RF Layout 3pi/2 for Discussion

RF Distribution – Neglecting Vacuum Support Platform

RF Distribution – With Vacuum Support Platform

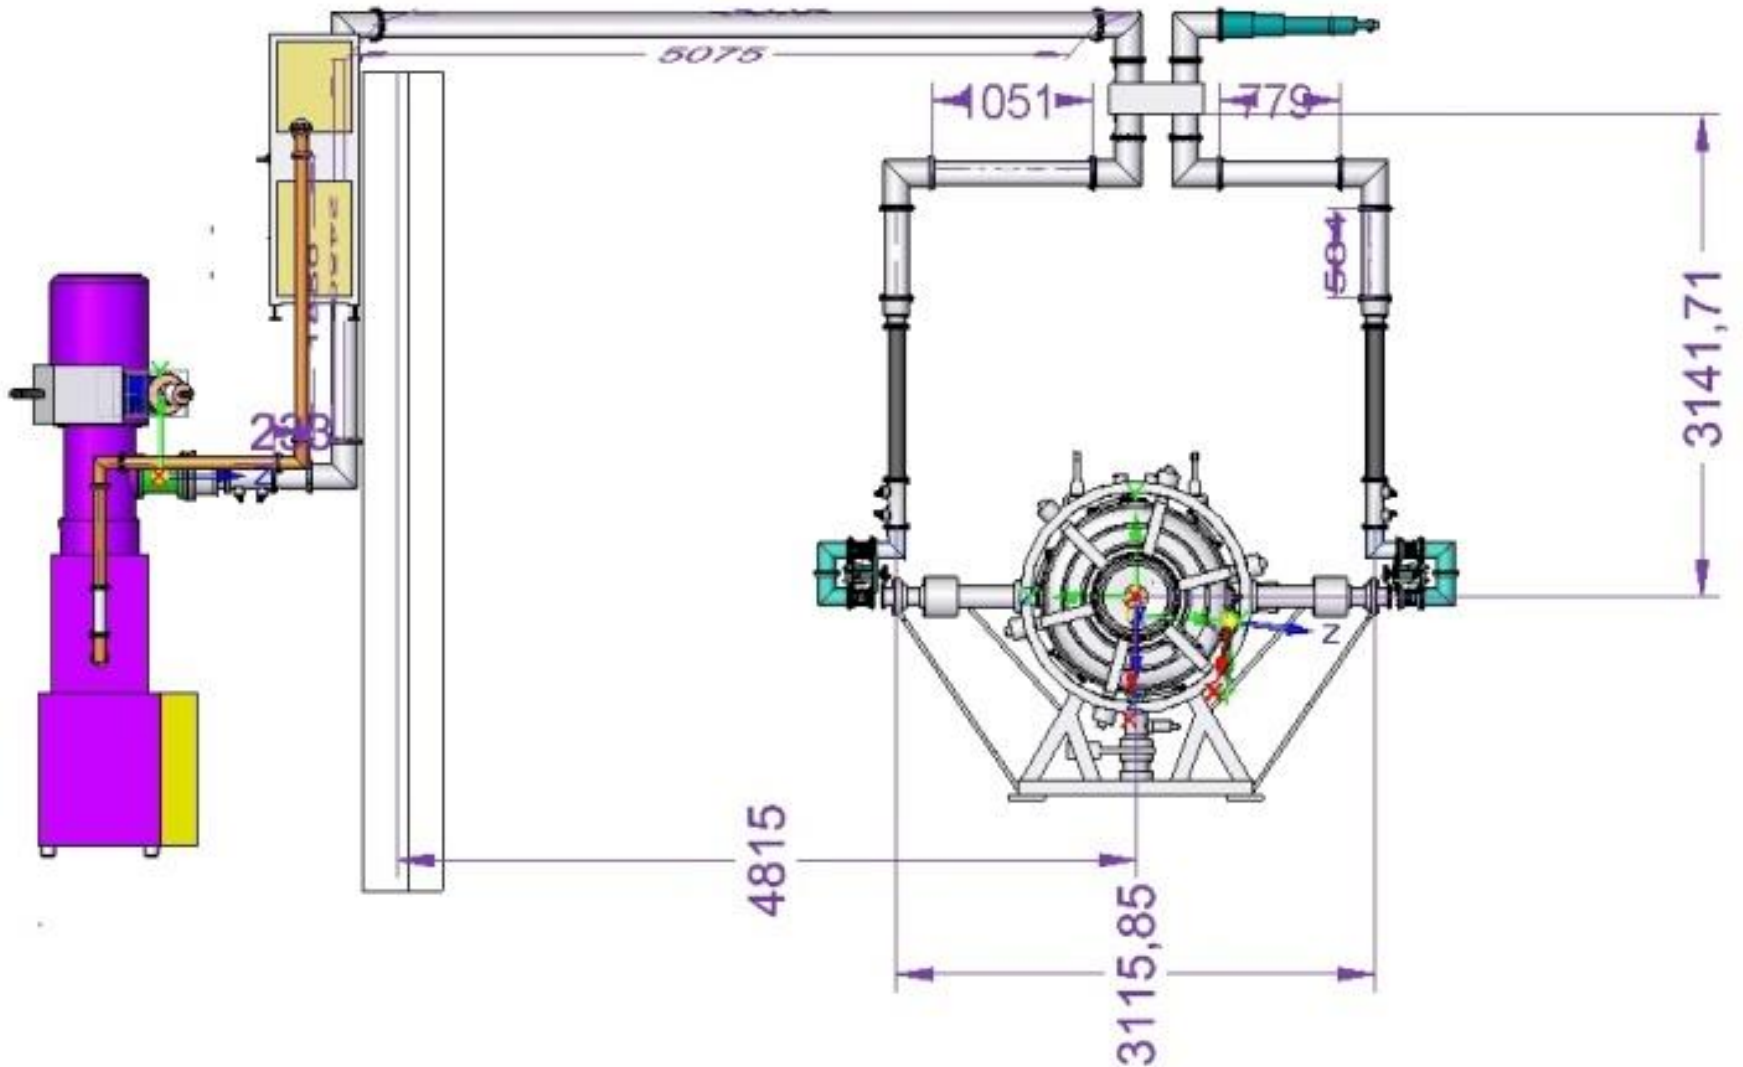
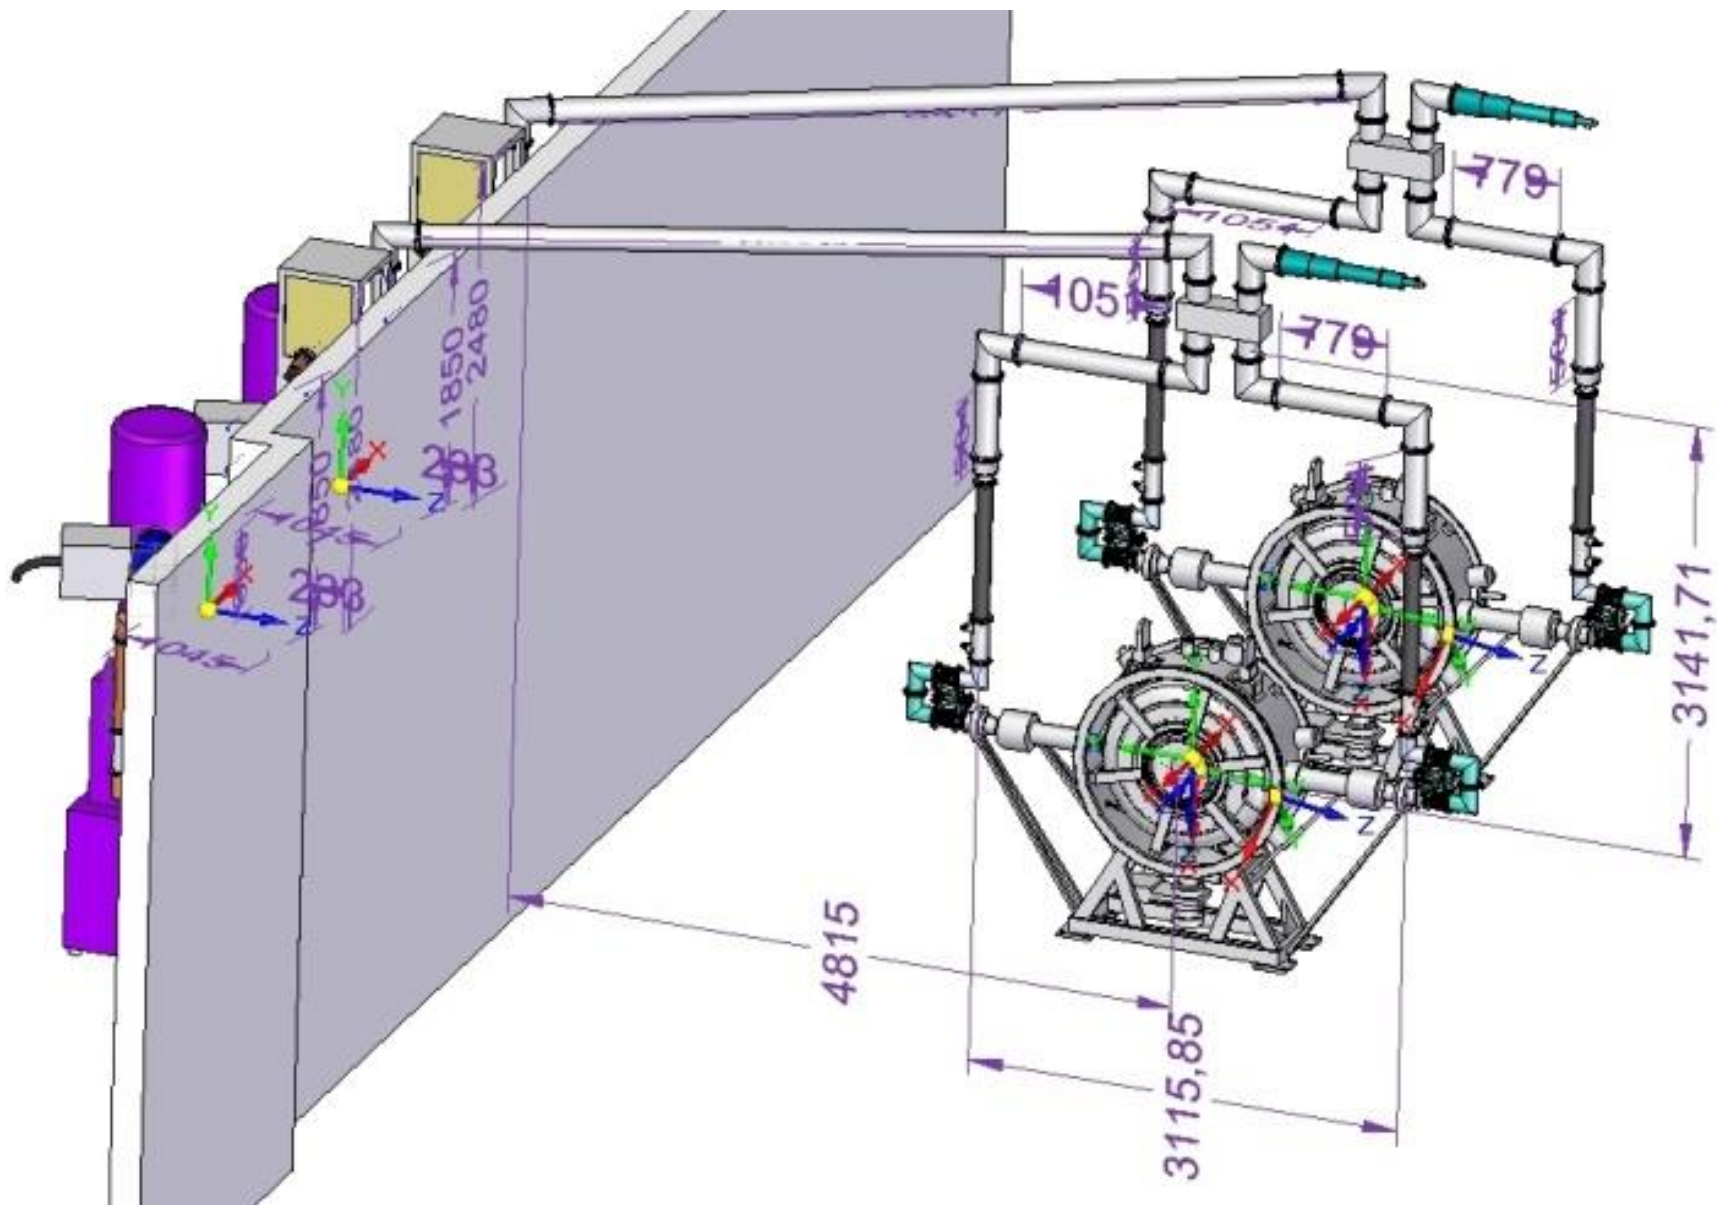
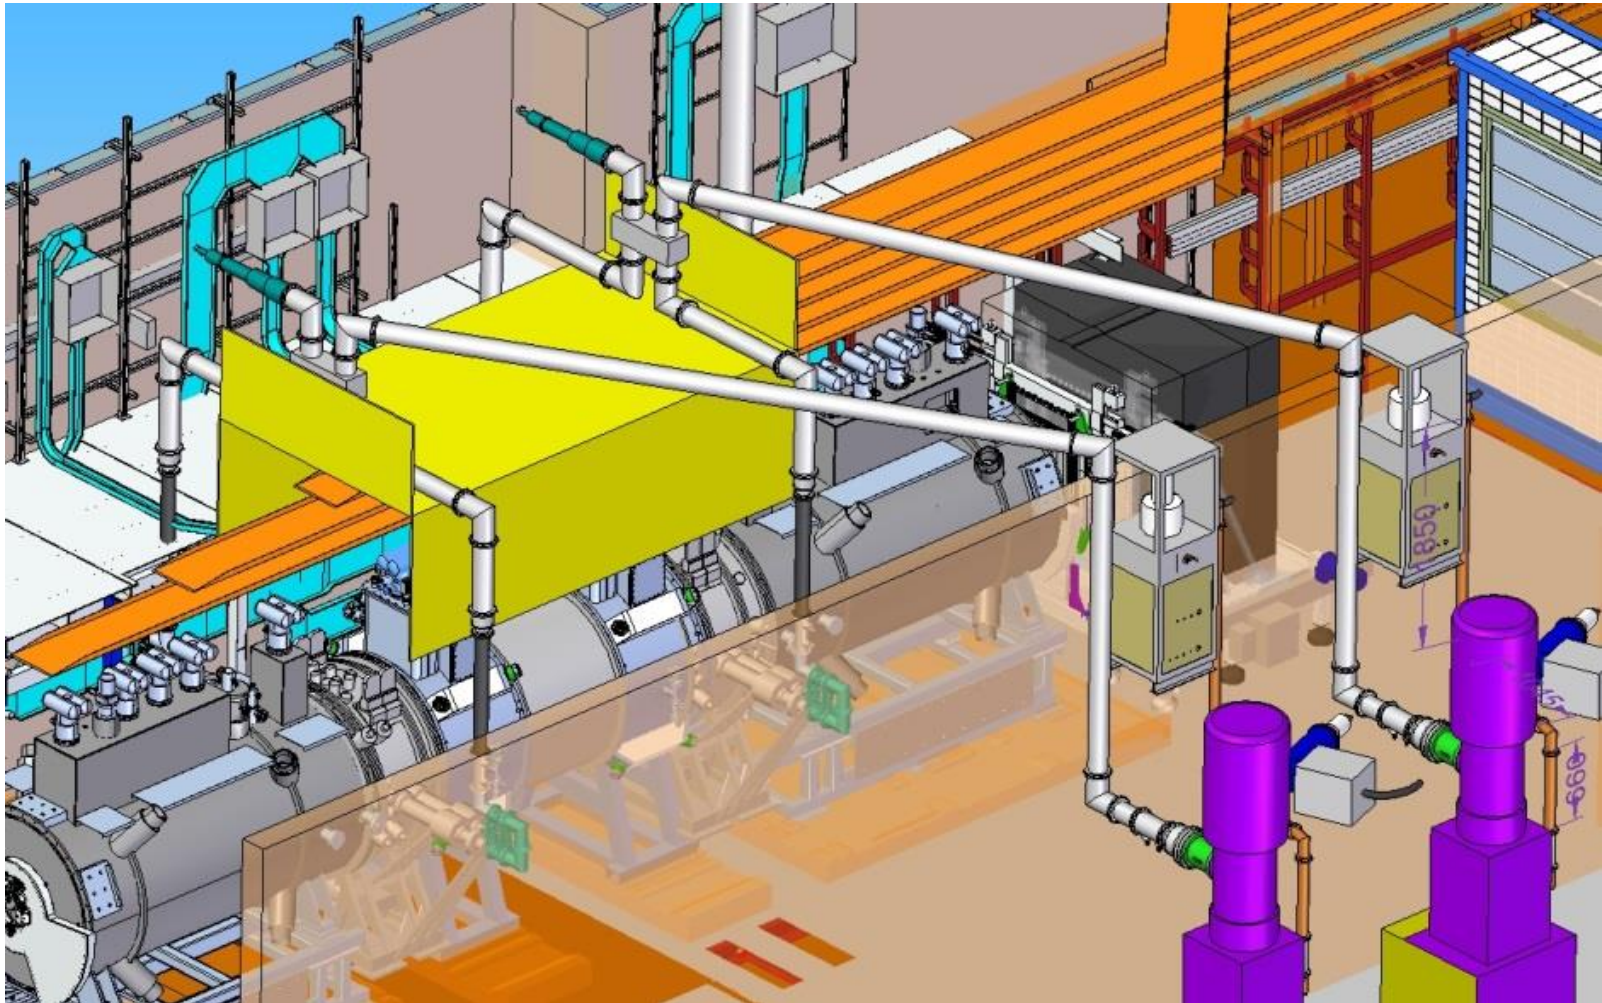
- Coax over the wall raised to avoid clash with vacuum support platform
- Crane hook height fully retracted may cause a potential clash with the coax.....need to check
- Option for crane operation maybe to skate equipment under high level coax line
- Services to dummy loads not yet been considered.....need to speak to Jason

- RF components routed over SS vacuum support platform “Dog Kennel”
- “Dog Kennel” can provide shielding for RF components
- Raised the height of the coax line over the wall from 242mm to 410mm.....will have to check crane height (potential clash)
- Hybrids splitters can move upstream & downstream & lowered to avoid any potential clashes, achieved by setting correct rotation angles on coax lines
- Suggest mounting coax supports off PRY steel work & “Dog Kennel”need to liaise with Jason & Steve Plate

RF Distribution – Hybrids Behind North Wall

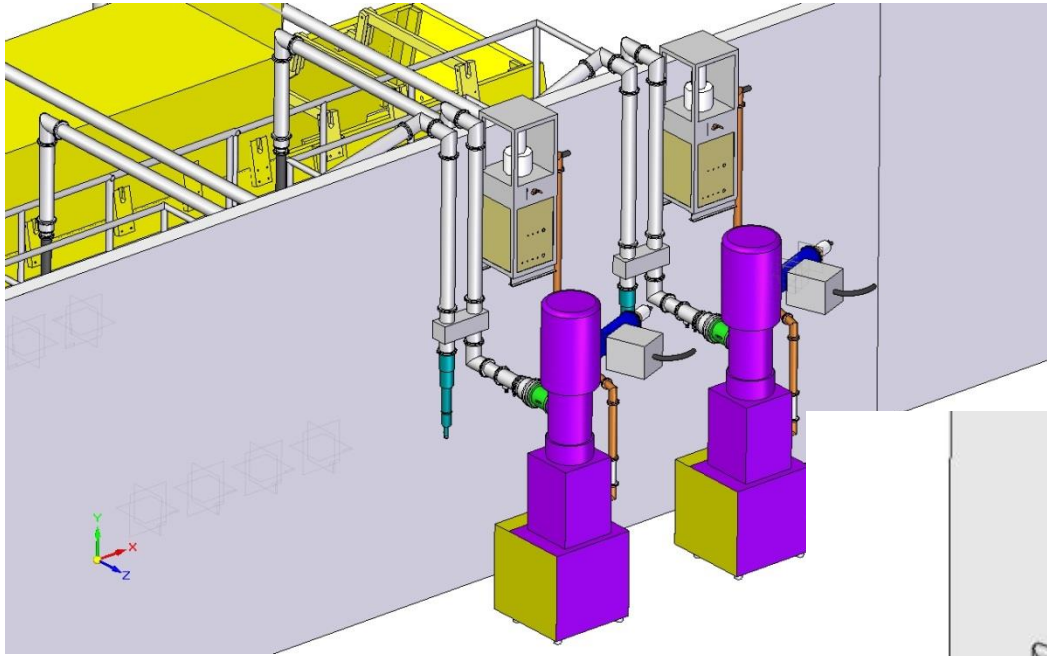
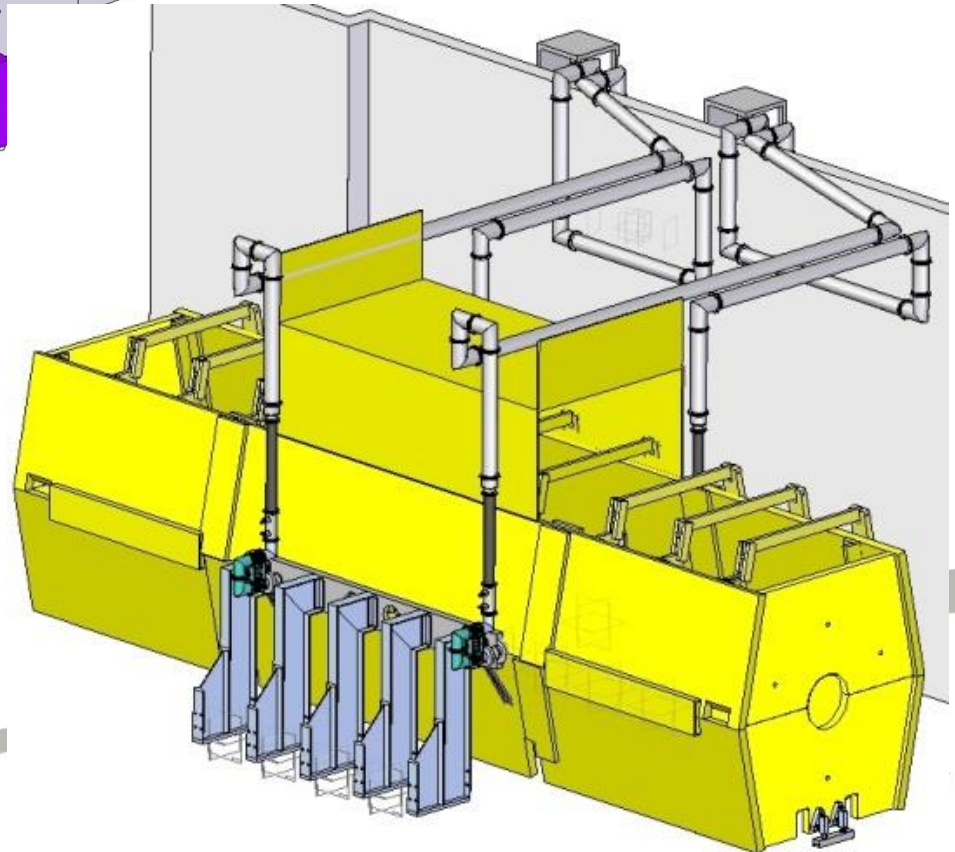
- Hybrids and elbows no longer above cooling channel reducing stray field effects.....if stray field is a problem!!!
- Coax can run lower once over the wall
- Services to dummy loads might be easier

- More coax required to match lengths to each side of the cavity
- More elbows required.....need same number of elbows to each side of the cavity to equalise the losses to both sides
- Generally more losses due to increased lengths of runs
- Larger SF6 volume required

RF Distribution – Hybrids Behind North Wall

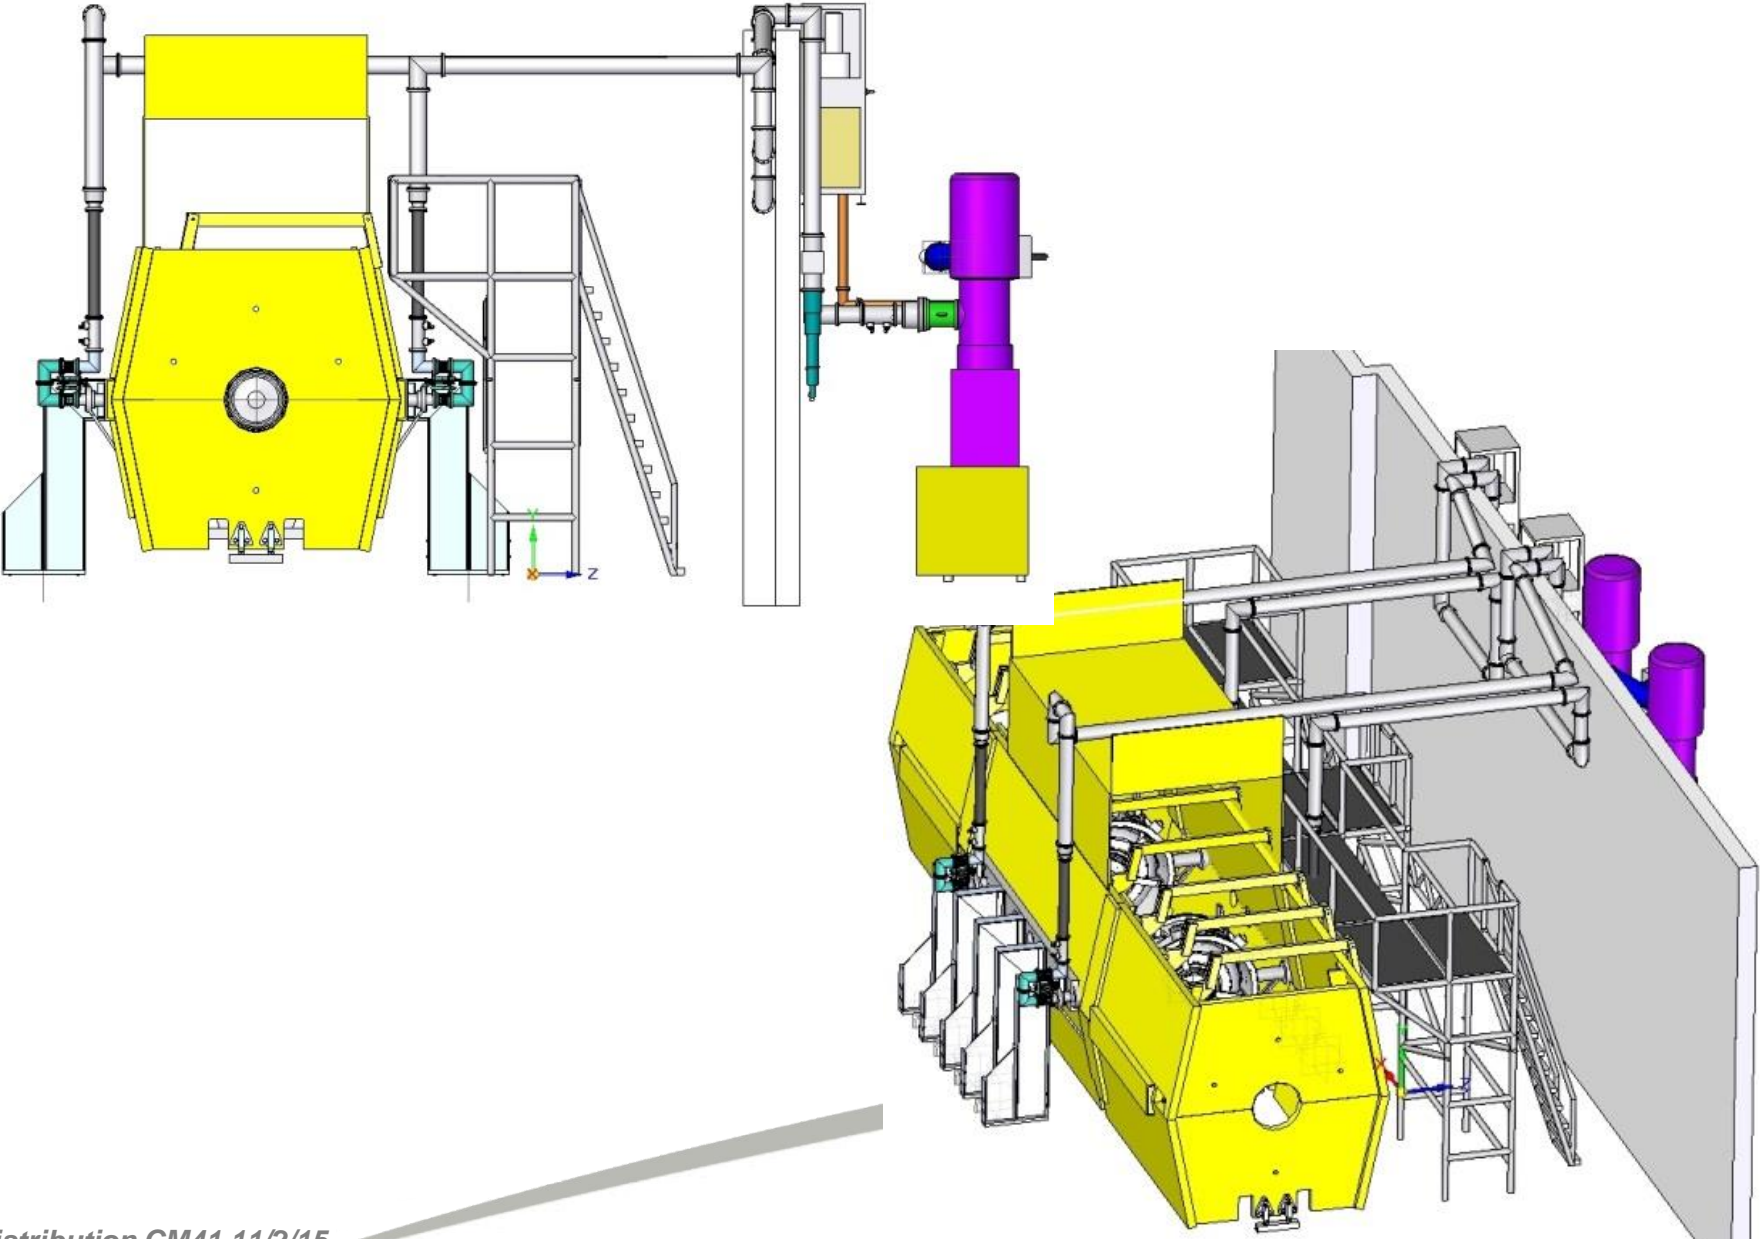
- Output line from amplifier is lower than the PRY, so needs to go high to clear PRY to couple to South RF couplers. True for all options.
- No advantage of going through the wall.

- Crane hook height fully retracted may clash with the coax. Original height of coax above wall was 242mm, increases to 410mm for vac services platform option. May need to skate loads under high level coax lines to avoid venting and refilling with SF6.

- Directional couplers included in layout 3 in total (1 off 6 inch, 2 off 4 inch).....these have been delivered
- 4" flexible coax 1m long shown in vertical lines.....these have been delivered

- Line trimmers to take up any length corrections.....these have been delivered
- Hybrid shown with existing 500KW loads (2off)these have been delivered

- Moved the second amplifier to position 3 behind wall to allow more space
- Run coax in 6inch as far as possible to the flexible coax line
- Will require additional and/or modified 6inch coax line lengths

- Current scheme is 4" coax under floor, be very difficult to run 6" coax under the floor
